VSUB Spike modification - Solution

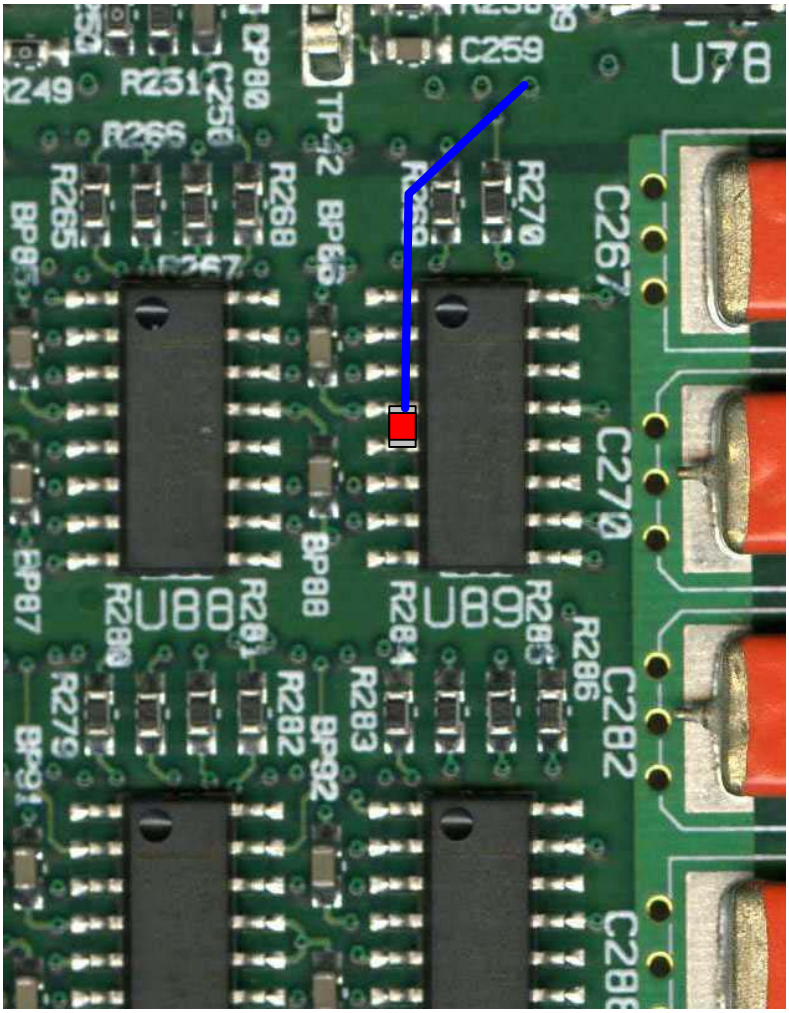
Lift pin 4 of U89 so that it does not connect to the pad(-5vA) below it. Add a 0.1uf 0603 size capacitor between the lifted pin and pin 5. Add a wire between pin 4 and the via(-15Va) shown below. .
